MEMORANDUM

SUBJECT: Review of the following:

Re: Plan Commission Submittal Comments–June 24, 2024
Preliminary Plan Review Comments for Private Improvements at Leo Living Development (Leo)
Tax Key IDs 37-4-121-122-0334 and 37-4-121-111-0400
Village of Bristol, Wisconsin (Village)

Figure 2: Proposed Wetlands to be Filled (Source: Applicant)

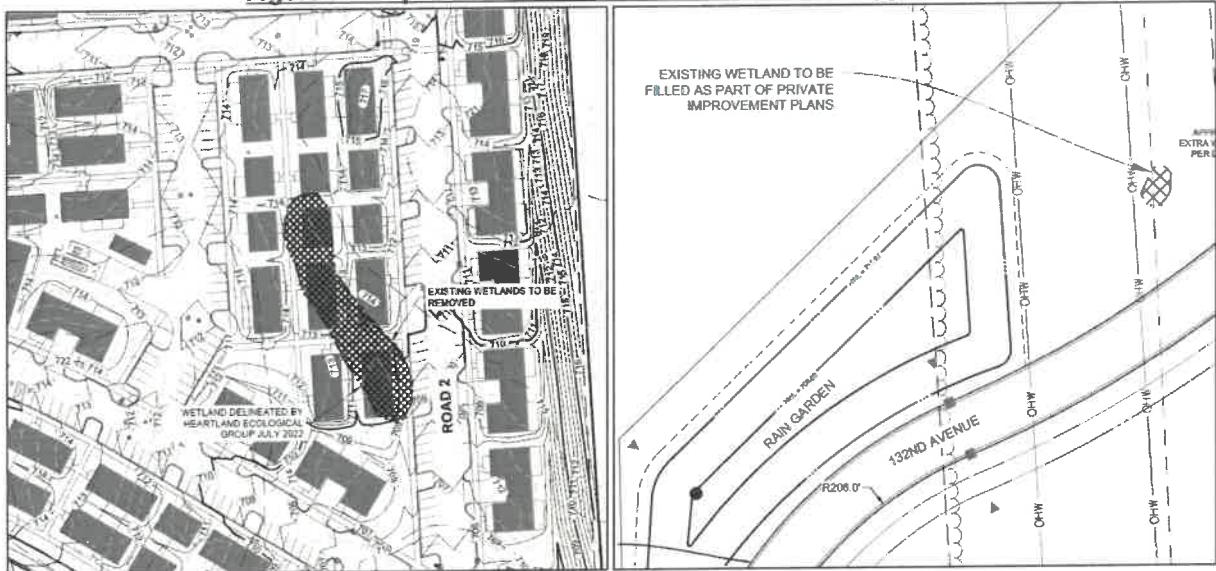
- A. The Applicant has sought non-federal wetland exemption for the wetlands on the Subject Property. Correspondence from the Wisconsin Department of Natural Resources in the submittal "RE: Leo Living Bristol Northeast Parcel Non-federal Exemption Request" (2 sheets, dated 04/30/24) has been provided showing approval for non-federal wetland exemption. State-approved non-federal wetland exemption does not exempt the Applicant from local regulations. Local regulations are discussed below:

- B. Title 14, Table 4 specifies the Natural Resource Protection Standards for wetlands, streams, and floodplains. Mitigation is permitted in non-residential districts for wetlands, streams, and floodplains, but mitigation is not permitted in residential districts for wetlands and floodplains. The intent of this restriction in residential districts is interpreted as a mechanism to ensure compliance because small-lot residential development is not subject to the same oversight as other types of development. Due to the nature of a Planned Unit Development (PUD) being a special district, Village Planner is not concerned about the filling of these isolated wetland pockets because the PUD is not a typical residential district and the developer may be held accountable to ensure mitigation is conducted. **Applicant shall submit a Natural Resource Protection Plan demonstrating that 100% of the disturbed wetlands shall be mitigated within the same sub-watershed.**

- a. Defer to Village Engineer for method of mitigation

Figure 3: CORP Plan for Root River Trail (Source: Village of Bristol)

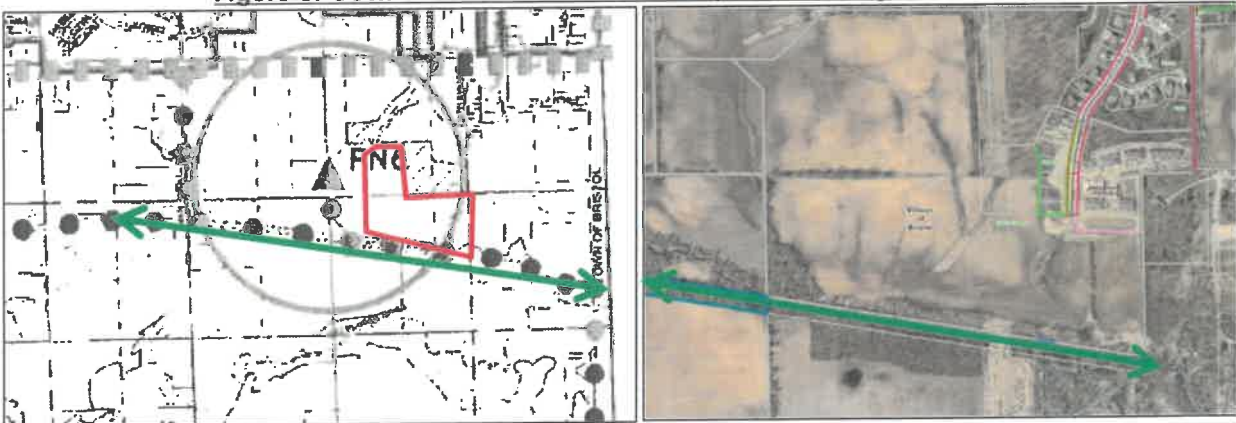
- a. No bicycle paths are proposed within the development; however, 10-foot paved sidepaths are adequate for shared use between cyclists and pedestrians so long as they are not signed to prohibit cyclists. Further, private streets within the development are anticipated to be bicycle-friendly due to their geometric design. However, there are insufficient improvements proposed connecting the Root River for a trail as planned in the 2009 CORP. A paved path should connect the development to this future trail corridor and could be included within the 20' horse path trail easement (See Figure 7).

- b. **The Applicant shall pave a ten foot (10') wide trail in anticipation of connecting to the future Root River trail.**
- E. Street Lights: Street lights shall be installed along all streets proposed to be dedicated to the public. Because the proposed development consists mainly of private streets, street lighting internal to the site beyond "Public Road 1" is subject to review in a Detailed Implementation Plan following Site Plan Review procedures.

Figure 4: Existing Trees to be Preserved (Source: Applicant)

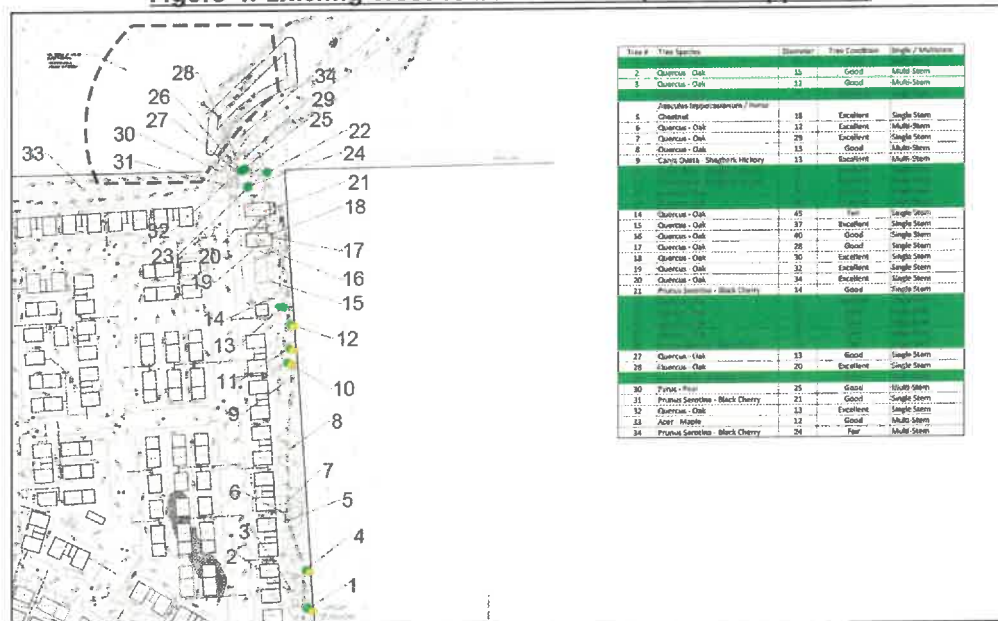
- a. The Applicant has tried to preserve 12 large trees along the eastern property line. According to the Applicant, due to the need to table the site through grading to minimize slopes caused by the over 30' elevation change from the east to the west property lines, most trees within the property line along the eastern wooded area are under threat from grading. However, the Applicant submitted that approximately twelve (12) trees may be able to be saved with adjustments to the proposed swale contours (Figure 4). While any grading activity within the critical root system of a tree threatens the tree's survival, these trees may withstand the proposed grading if revised.

Figure 5: Stream Locations (Source: Applicant)

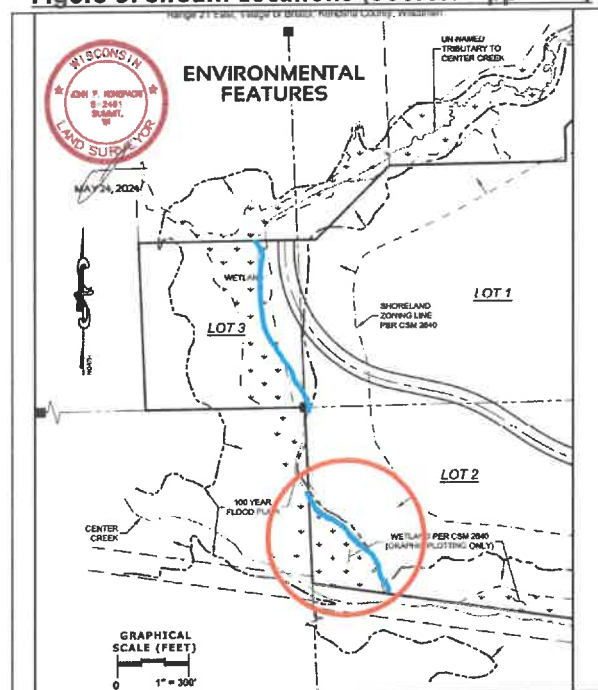
- a. The Applicant has not proposed any stream or lake shore access easements. The Applicant shall provide a public stream access easement to the stream on the Subject Property connecting to the proposed "Public Road 1" dedicated to the Village of Bristol.
- K. Limited Access Highway Treatment: CSMs adjacent to a limited access highway such as STH 50 are typically required to include a landscape bufferyard including berm and landscape easement. However, because no improvements are proposed or planned for Lot 1 of CSM #1 – the "Tricoli Parcel," Village Planner recommends waiving this requirement until future development of the parcel is proposed. It is likely that the parcel will be developed in the future – designated as "Community

Figure 6: Proposed Mini-Parks (Top: General Development Plan; Bottom: Detailed Implementation Plan) (Source: Applicant)

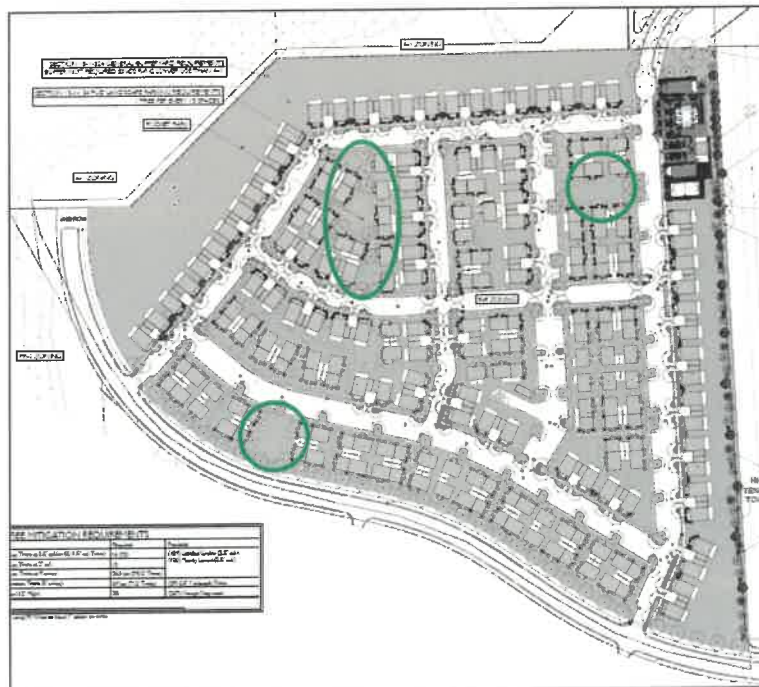
- i. The Applicant has reduced the number of mini-parks or "pocket parks" in the "Cottages" portion from five (5) to three (3). This is a substantial deviation from the General Development Plan in the opinion of the Village Planner.

No future park connection shown

- ii. **The Applicant shall revise the Detailed Implementation Plan to include five (5) mini-parks north of the proposed "Public Road 1."**

Figure 7: Proposed Horse Trail Easement (Left: Zoom in; Right: Full extents)

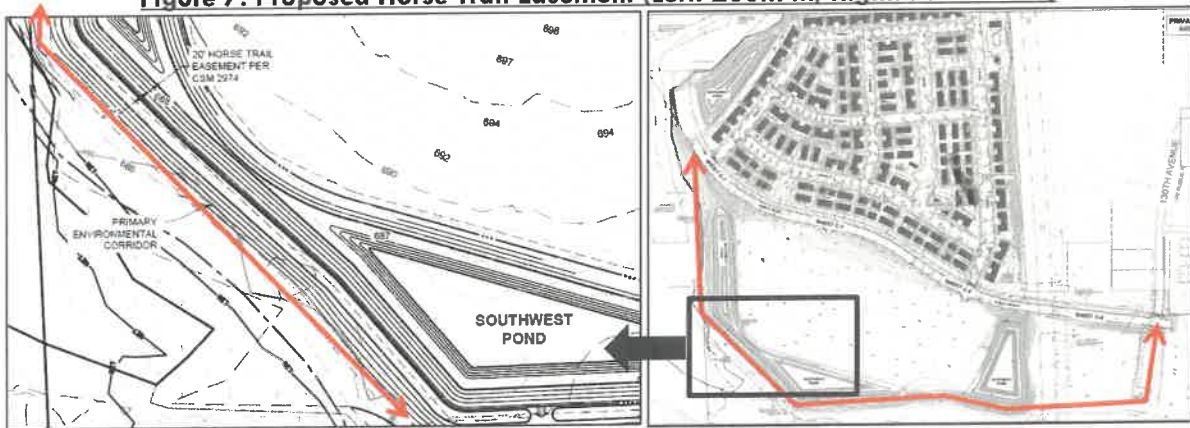
- iii. A 20-foot (20') "Horse Trail Easement" is shown around the southern portion of the site (Figure 7). The new trail does not show any improvements beyond grading and is assumed to be unpaved. No pathways are shown around the northern perimeter of the site providing access to the environmental corridors and stormwater ponds as required by the General Development Plan. No pathway east to connect to the future park beyond the overhead electrical lines are shown between buildings as required by the General Development Plan. Besides the changes in driveways, the pattern of parking facilities is generally the same as in the General Development Plan; however, overall counts may have changed.

1. The Applicant shall provide pathways around the northern perimeter of the site to provide access to environmental features and stormwater paths, and pathways to the east connecting the community building to the future park beyond the overhead electrical wires.
